PL-1 NEWSLETTER No. 5

ENGINEERING CHANGE NOTICE # 5

SHEET # 2
JAN. 1967

DWG 1-20.002

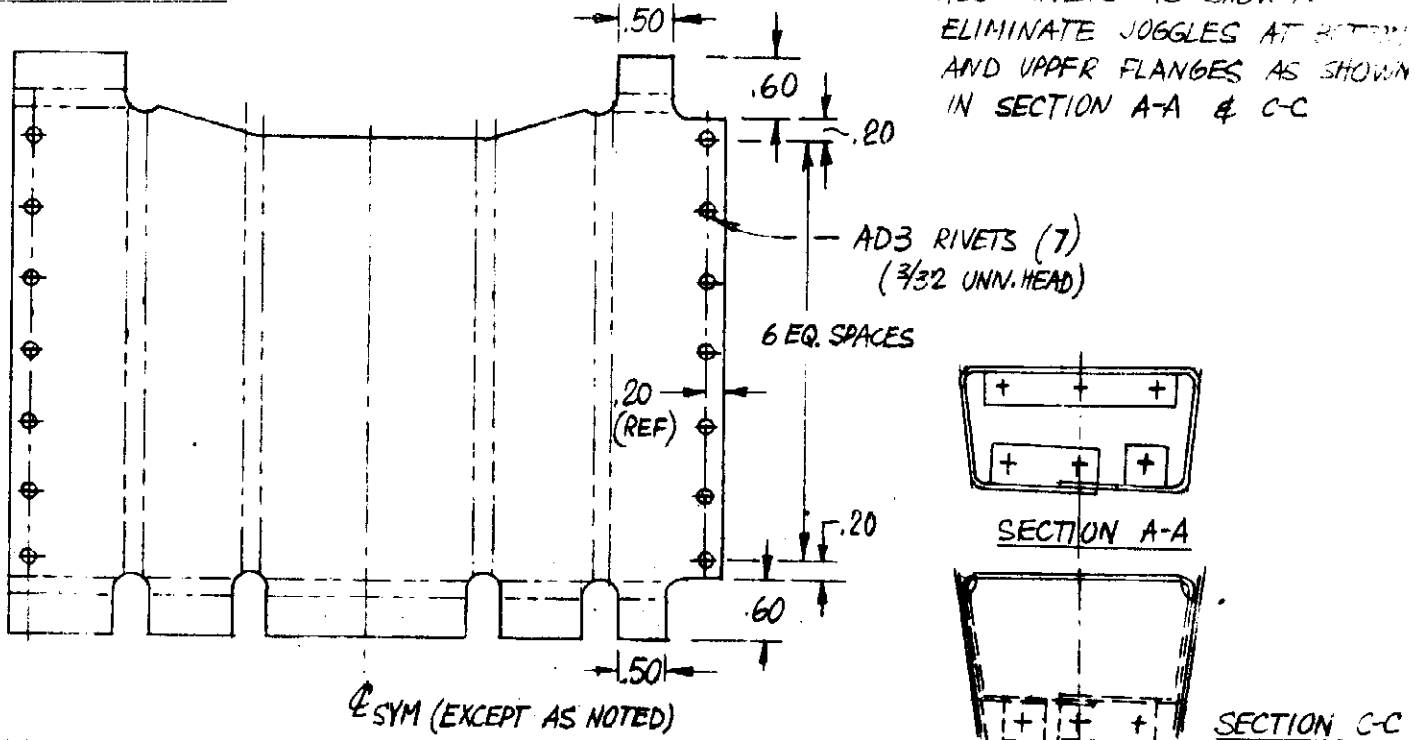
ADD RIVETS AS SHOWN.
ELIMINATE JOGGLES AT BOTTOM
AND UPPER FLANGES AS SHOWN
IN SECTION A-A & C-C

DWG 1-20.001

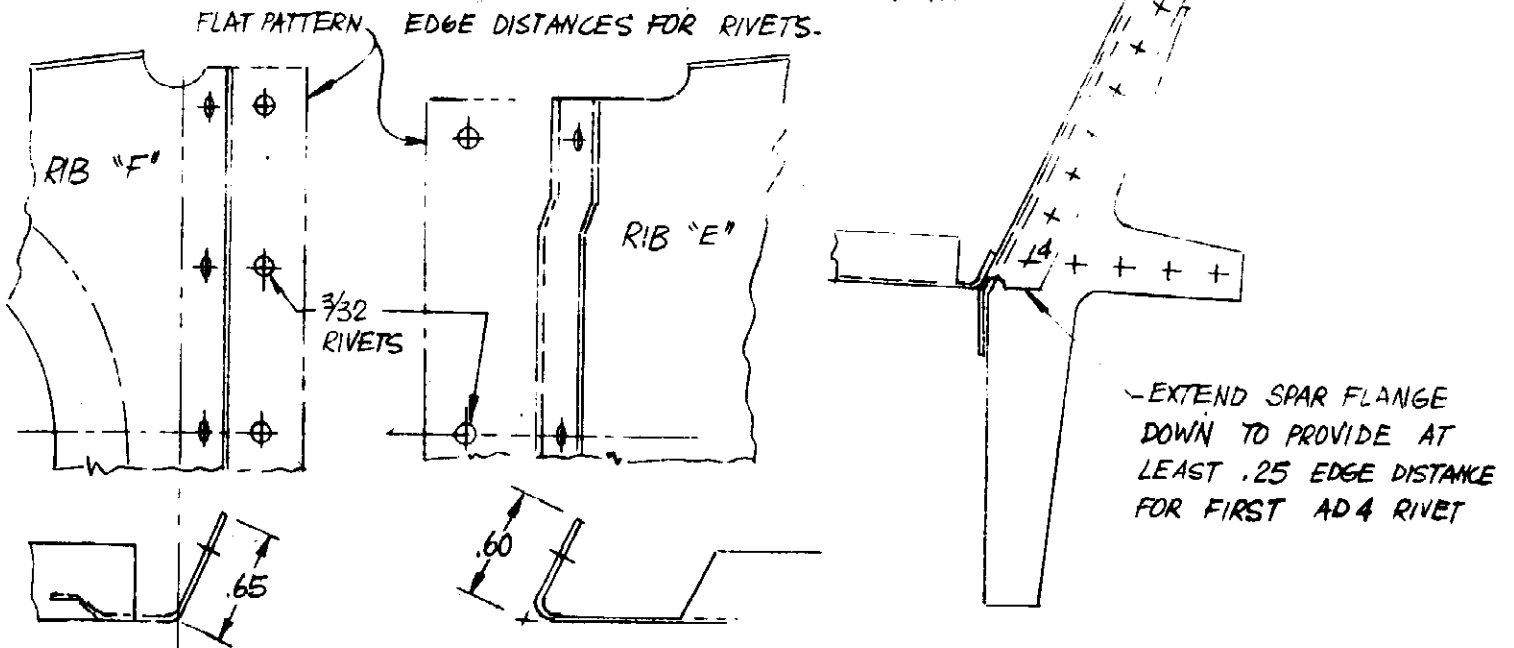
MODIFY RIB "F" & "E" FRONT SPAR ATTACHMENT
FLANGES AS SHOWN TO PROVIDE ADEQUATE
EDGE DISTANCES FOR RIVETS.

DWG -1-30.006

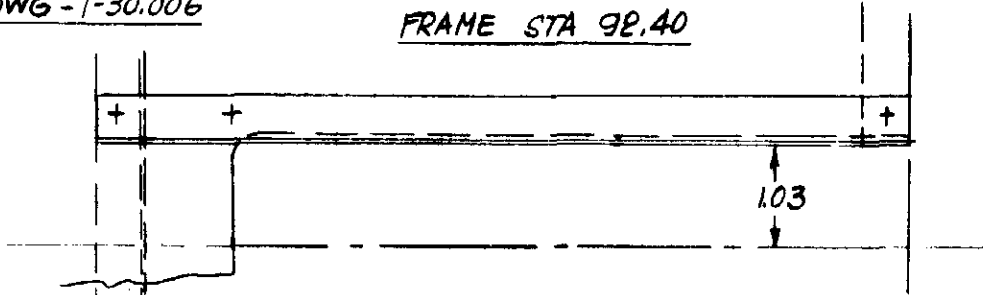
FRAME STA 92.40

CHANGE LOCATION OF ANGLE FOR ATTACHMENT OF FLAP BOX AS SHOWN. (DIMENSION WAS 1.00).

DWG 1-50.006

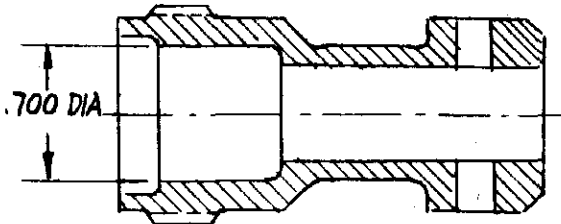
TRIM INDICATOR WORM (STEEL) AND TRIM INDICATOR (NYLON). THREAD PITCH SHOWN IS .400. CHANGE TO .166 (6 THREADS/INCH).

AD DIMENSION TO "HOUSING"

DWG 1-30.008

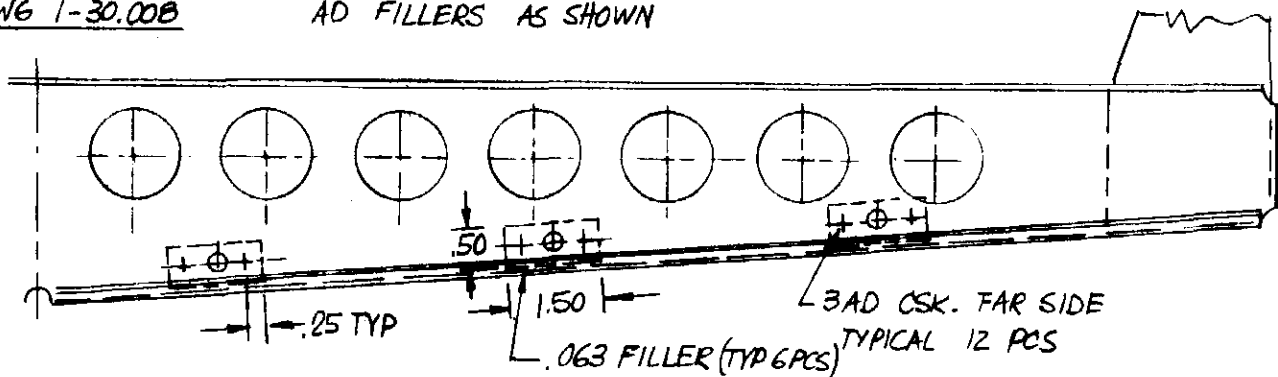
AD FILLERS AS SHOWN

DWG 1-10.008

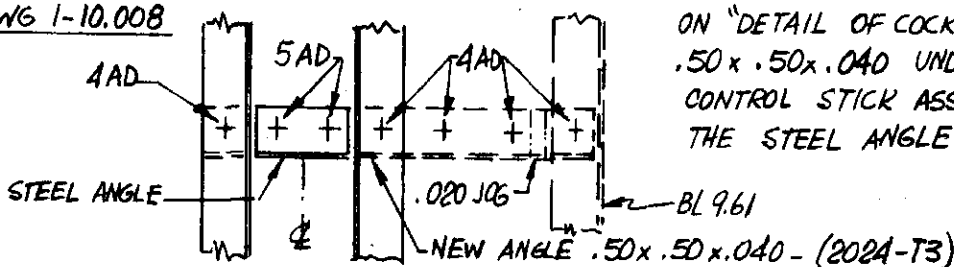
ON "DETAIL OF COCKPIT FLOOR" - SCALE 1/2 AD AN ANGLE .50x.50x.040 UNDERNEAT THE STEEL ANGLE PART OF CONTROL STICK ASSY. USE 5/32 RIVETS TO ATTACH THE STEEL ANGLE

DWG 1-50.002

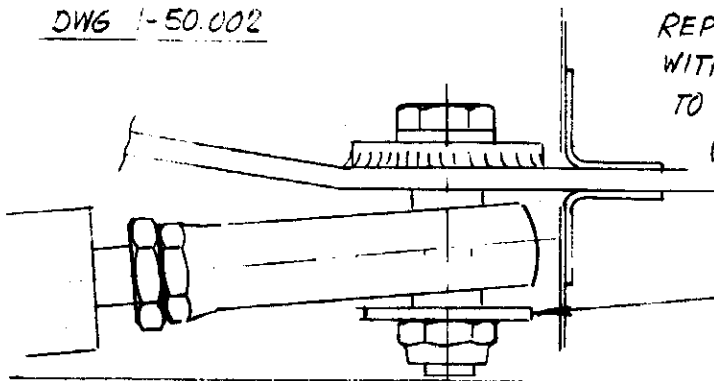
REPLACE THE AN 960-C416 WASHER UNDER THE NUT WITH A AN 970-4 WASHER. THIS IS A SAFETY MEASURE TO AVOID LOOSING CONTROL IF ROD END BEARING FAILS (SEE DESIGNEE BULLETIN #10-EAA-SPORTA/AT 21 SEP 30-1966).

AN 970-3 WASHER. INCREASE HOLE DIA TO .250

DWG 1-10.008

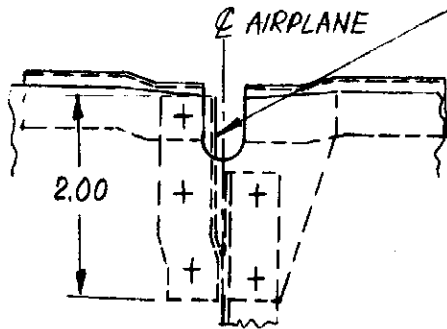
ON "DETAIL OF COCKPIT FLOOR" - SCALE 1/2:

EXTENDED .60x .60x .032 ANGLE AS SHOWN IN DWG 1-10.006

1-40.002

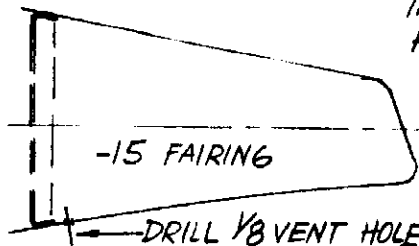
DRILL 1/8 VENT HOLES IN FUEL TANK AFT FAIRING. THIS IS REQUIRED TO AVOID DEFORMATION DUE TO CHANGE IN TEMPERATURE OR ALTITUDE
